Access Compliance Report Public Rights-of-Way (Curb Ramps)

Main Street: BLUME_DR Cross Street: SILVER_FOX_RD Location: NW

ADA ID: RPRK211208130817 Ramp Type: Type 1 - Perpendicular Diagonal Initial Pass/Fail: Fail Overall Compliance: No Severity Score: 15

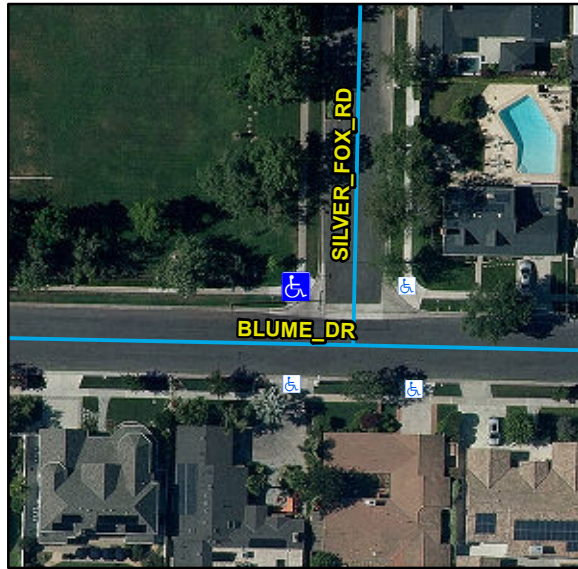
Compliance	Description	Data	Compliance	Description	Data
N/A	Ramp Length (in)	74	N/A	Flare Type LT	
Yes	Ramp Width (in)	48			N/A
No	Ramp Run Slope (%)	8.5	N/A	Flare Slope LT (%)	N/A
Yes	Ramp Cross Slope (%)	2.1	N/A	Flare Traversable LT	N/A
N/A	Landing Present	N/A	N/A	Flare Type RT	
N/A	Landing Length (in)	N/A			N/A
N/A	Landing Width (in)	N/A	N/A	Flare Slope RT (%)	N/A
N/A	Landing Run Slope (%)	N/A	N/A	Flare Traversable RT	N/A
N/A	Landing Cross Slope (%)	N/A	N/A	DWS Provided	N/A
N/A	Landing Movement Obstructed?	N/A	N/A	DWS Contrast	N/A
	Landing Movement Type	N/A	N/A	DWS Length (in)	N/A
N/A	Landing Shared	N/A	N/A	DWS Full Width	N/A
N/A	Clear Space	Yes	N/A	DWS Offset Left (in)	N/A
N/A	Clear Space To Crosswalk (in)	N/A	N/A	DWS Offset Right (in)	N/A
N/A	Marked Crosswalk 1	No	N/A	Marked Crosswalk 2	No
	Crossing 1 Direction	S		Crossing 2 Direction	E
	Marked Crosswalk 1 Width (in)	N/A		Marked Crosswalk 2 Width (in)	N/A

N/A	Ramp Inside Crosswalk 1	N/A	Yes	Ramp Inside Crosswalk 2	N/A
	Crossing 1 Slope (%)	7.8		Crossing 2 Slope (%)	3
	Crossing 1 Cross Slope (%)	1.4		Crossing 2 Cross Slope (%)	2.4
N/A	Gutter Ponding	N/A	N/A	Curb Slope	2.2
Yes	Gutter Lip Height (in)	0		Road Run Slope (%)	2.8
N/A	Gutter Run Slope (%)	N/A		Road Cross Slope (%)	3.1
N/A	Gutter Cross Slope (%)	N/A			
Yes	Overall Surface Condition: Acceptable		Yes	Perp Joint Present	Yes
	Cross Gutter Present?	Yes		Spandrel Present?	Yes
	Replace Cross Gutter?	No		Replace Spandrel?	No

Remove & Replace Curb Ramp With Two New Directional Ramps or Equivalent.

R304.2.2, STD 1115
